Urban Design Review

ATC Royal Randwick Racecourse – Hotel Development

October 2013

Signage:

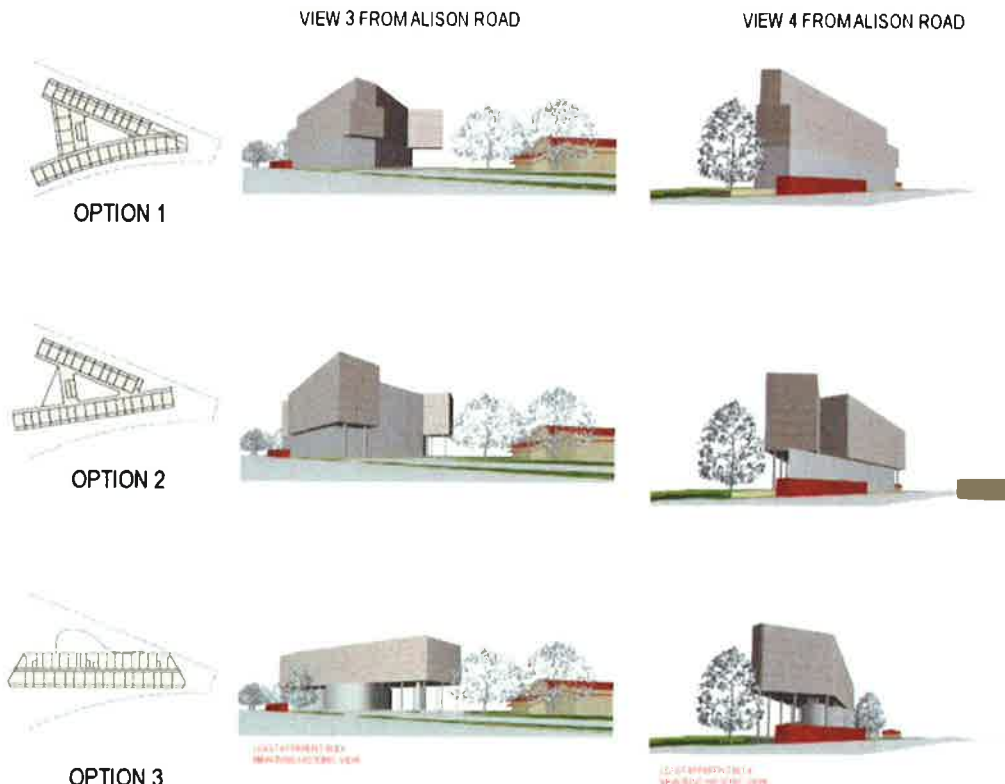
The changes to the proposed signage included:

- Signage on the street facade - removal of rooftop signage and relocation to incorporate part of the previously used logo into the facade on upper level (8th storey) below the edge of the parapet. The signage on the facade was shortened from the 'Adina Royal Randwick' to 'Adina'. It was also reduced in size from the height of approx. 3m to no more than 2.5m.
